INVITATION TO BID

Fire Restoration

Villages at South Station 3714 South 154th Lane, Tukwila, WA 98188

ADDENDUM NO. 1

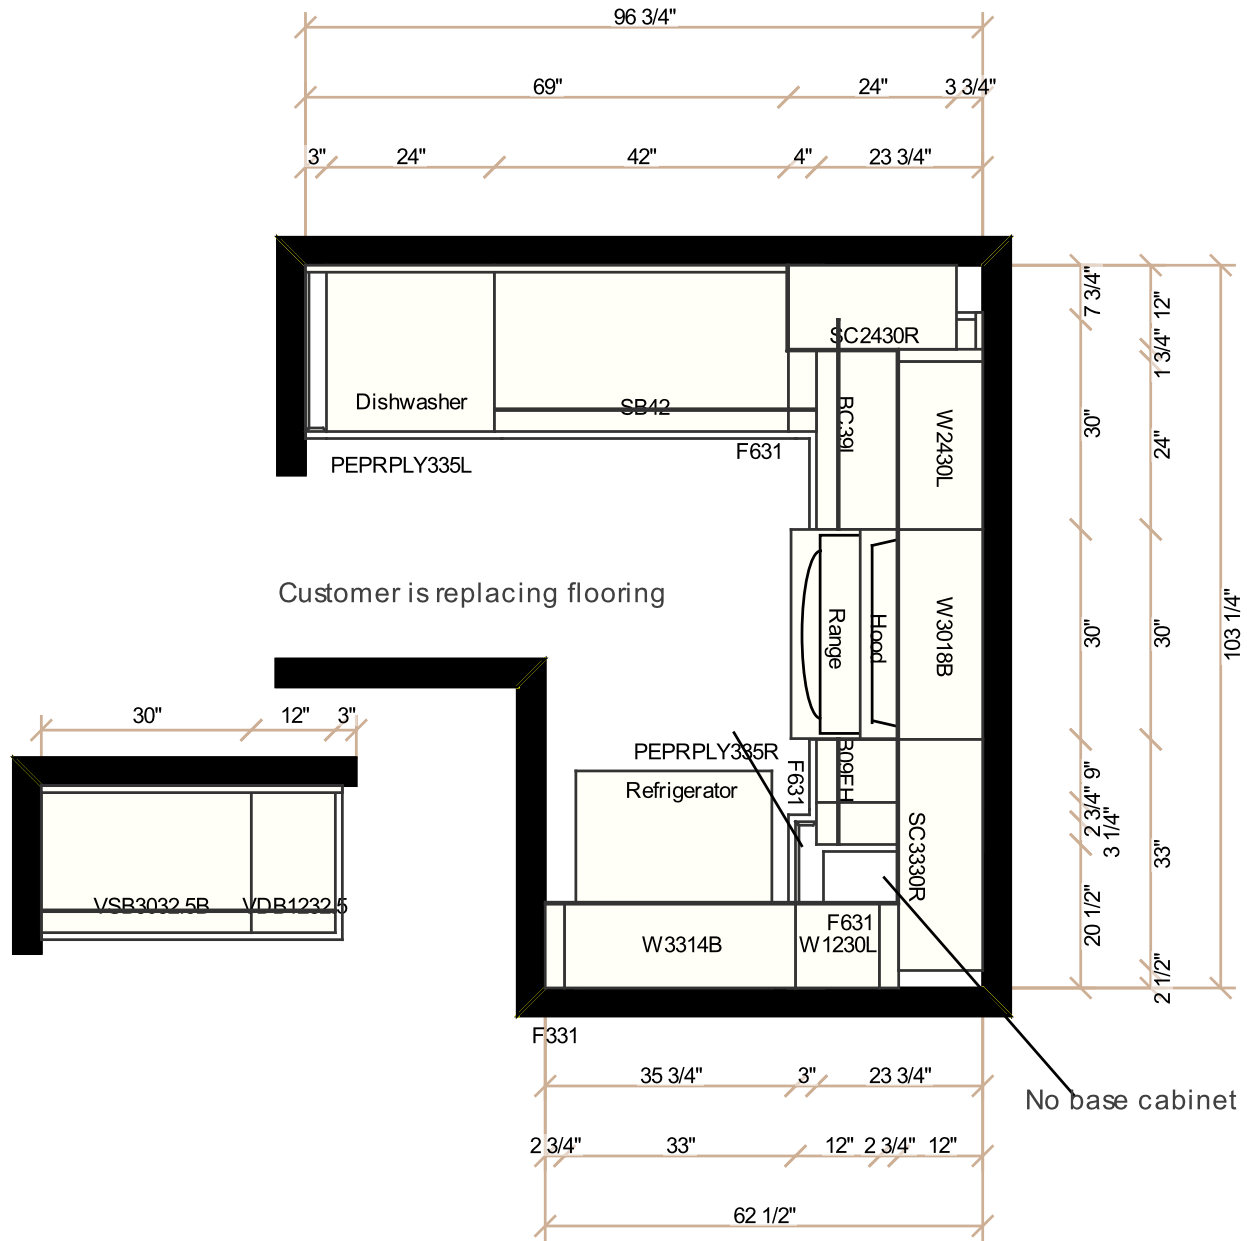
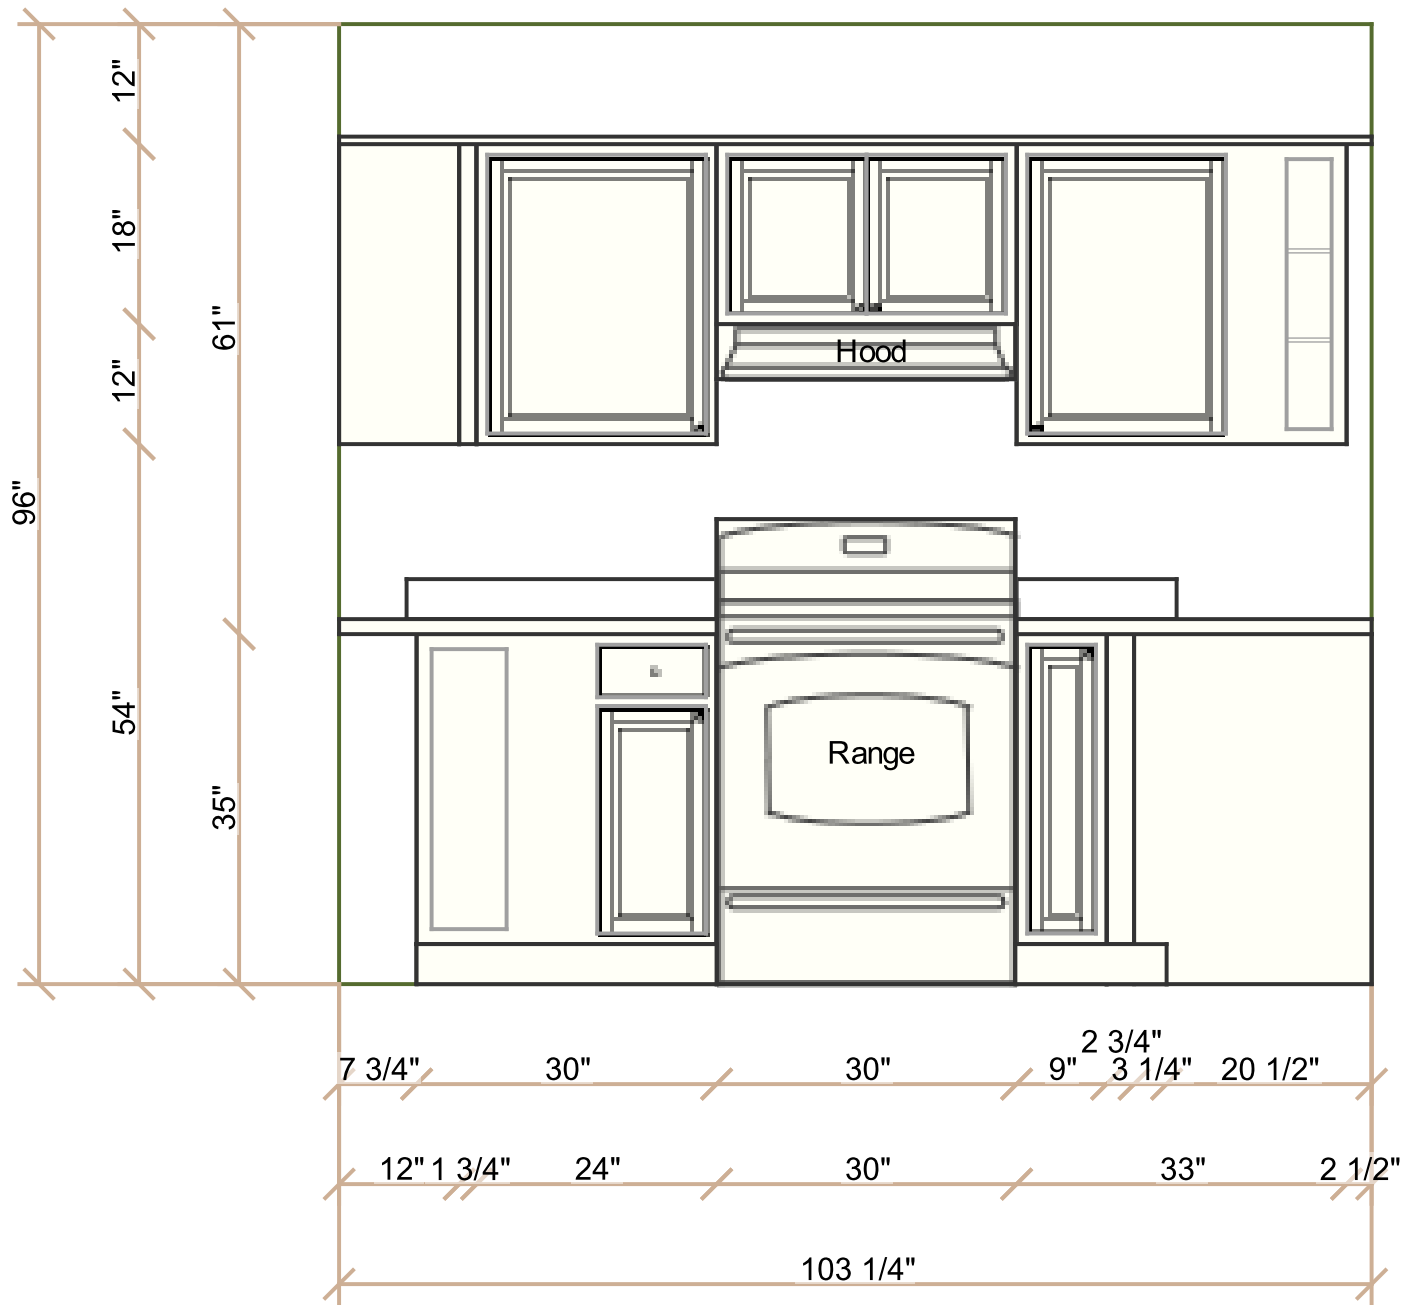
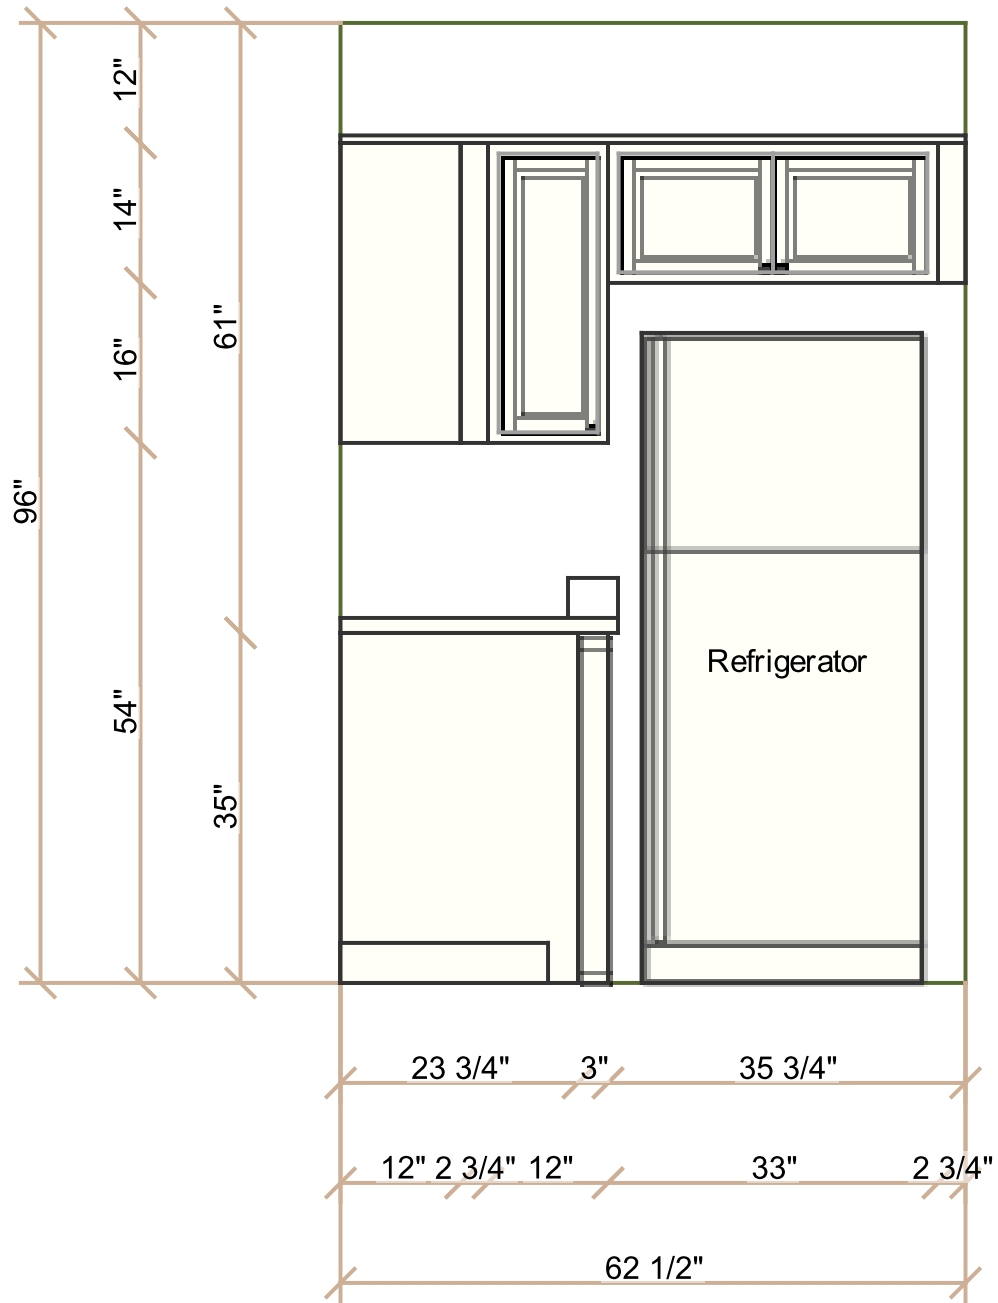
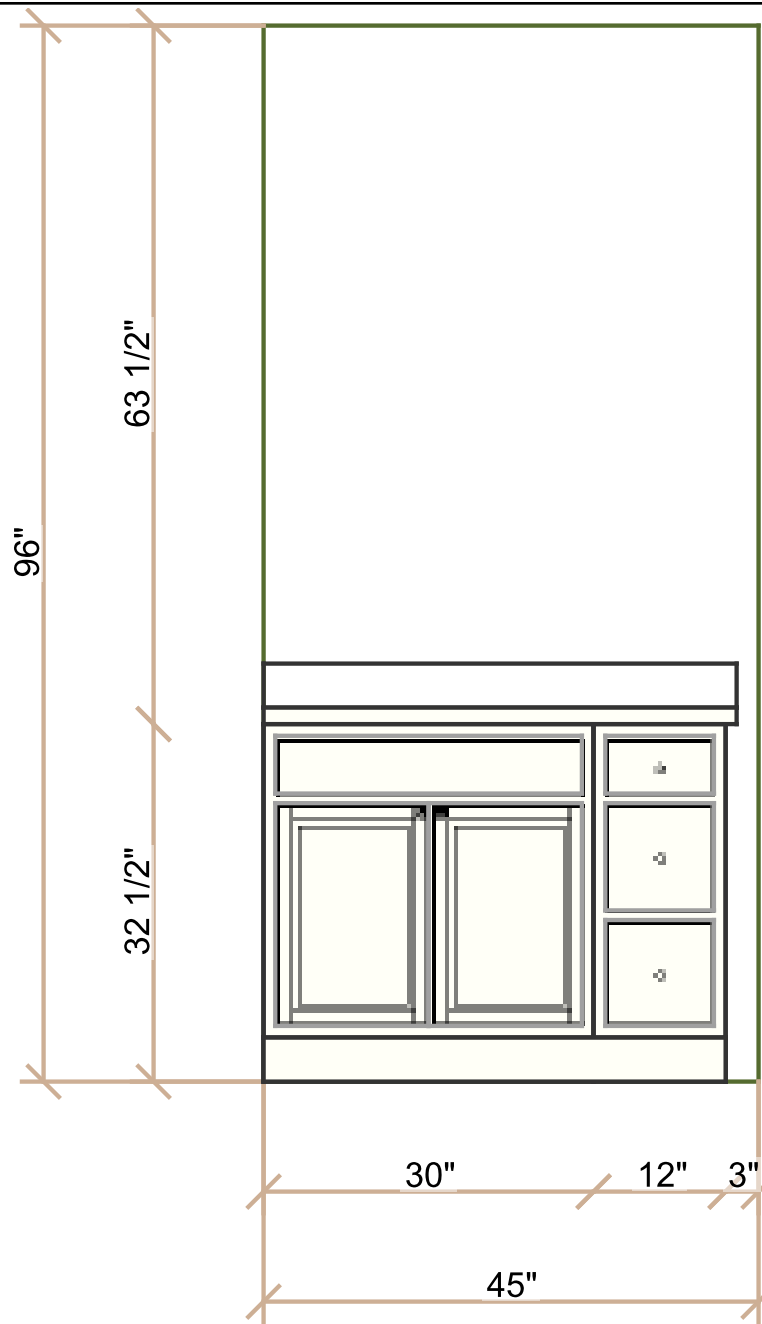
Question #4 – Do you have specifications for the cabinets and is the bar countertop to be replaced?

Answer: Cabinet manufacturer is Aristokraft, style is Sinclair from Home Depot. The bar top is to be replaced along with the other countertops so all tops match. Countertop to be Topline Counters “Maui Quartz” solid surface. Provide layout sketch and cabinet submittal prior to ordering for approval by owner. See attached Cabinet Details, Cabinet Finishes and Cabinet Plans for additional information

Customer is replacing flooring

No base cabinet in corner
